# Enhanced Approximation for RBIR PHY Abstraction in TGM

## IEEE 802.16 Presentation Submission

IEEE C80216m-08/067r1

To modify the 802.16m EVM document related with Approximation part for RBIR PHY Abstractions

# Accuracy of SI approximation

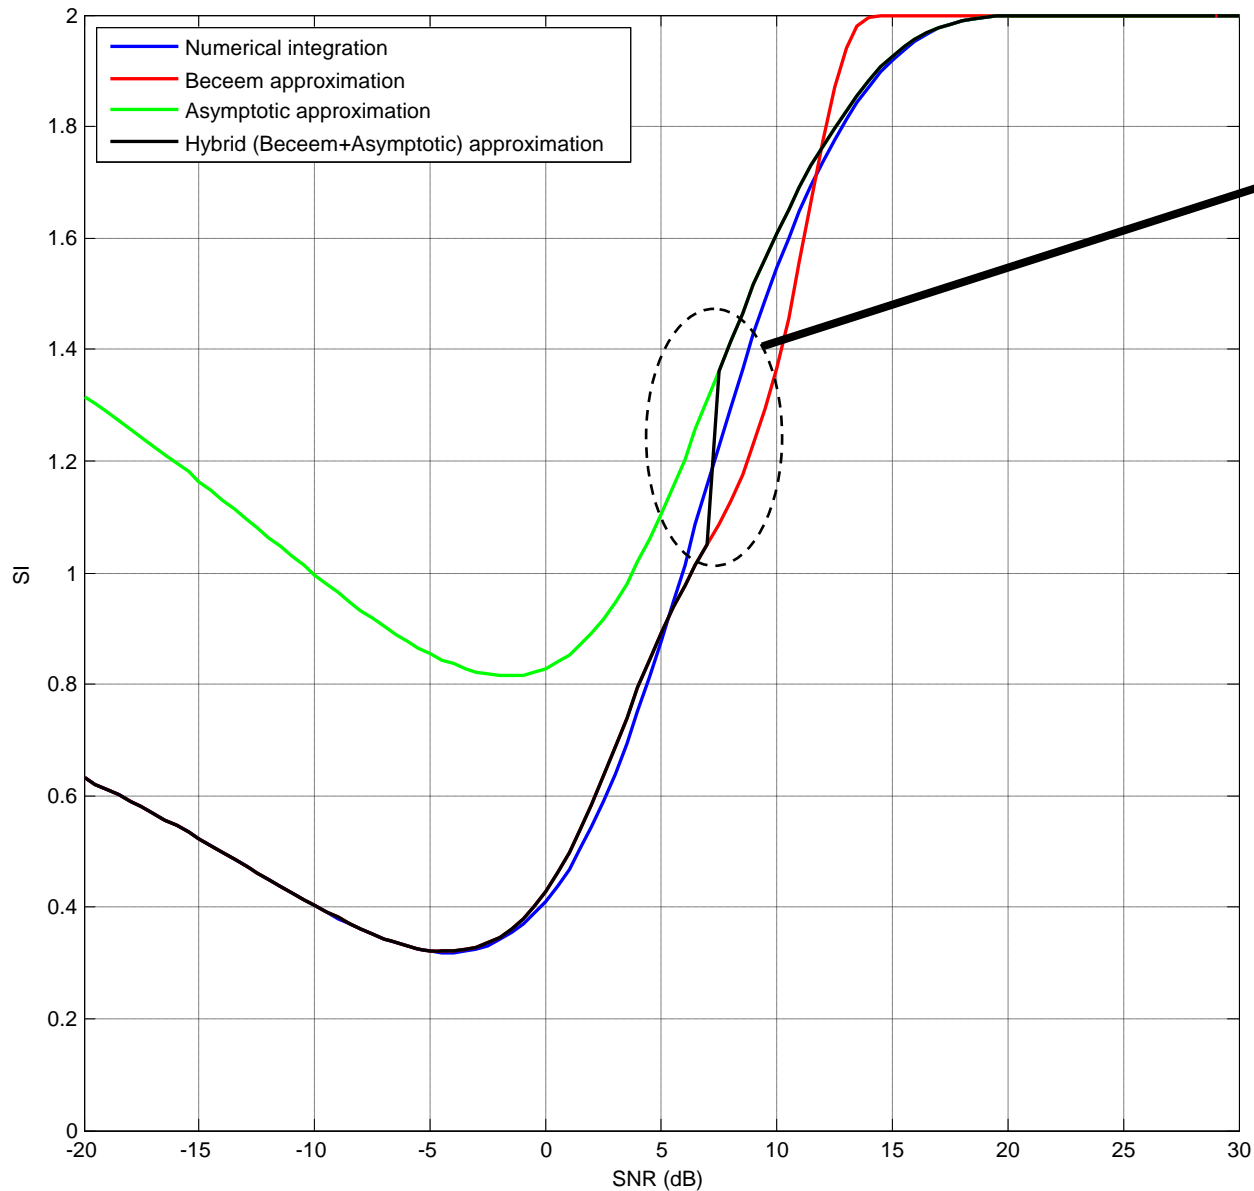
**Switching point  
( $J \approx 0.65$ )**

**Perfect matching  
of hybrid scheme**

# Accuracy of Implementation

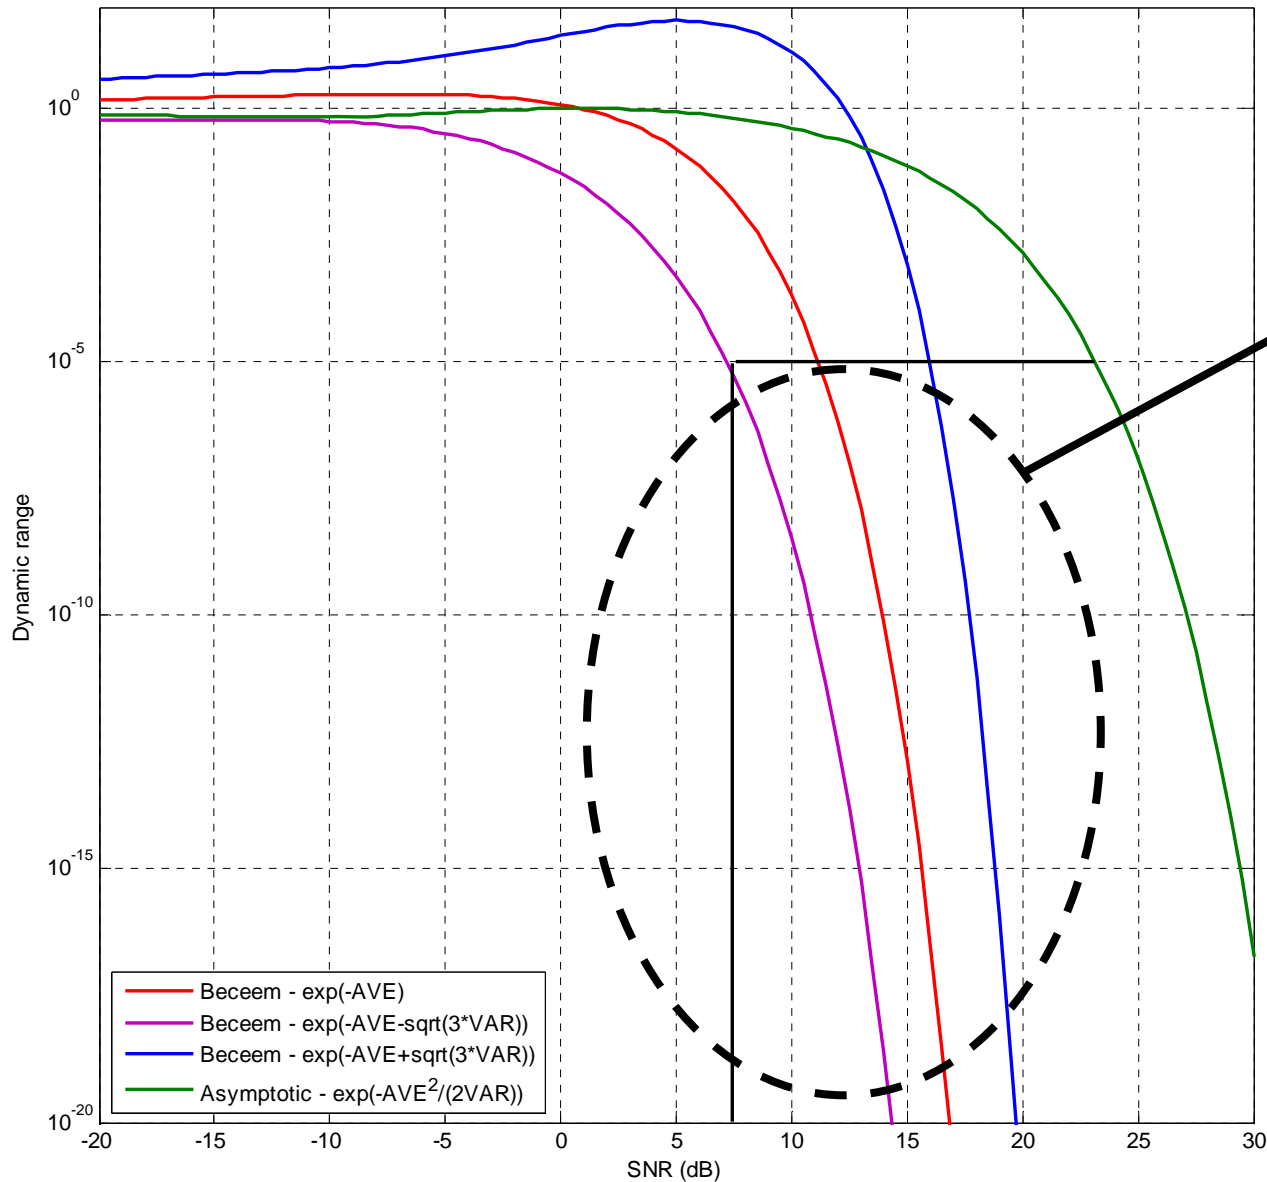
**Region of high dynamic range for Beceem elementary functions**

**Avoided by Hybrid scheme**
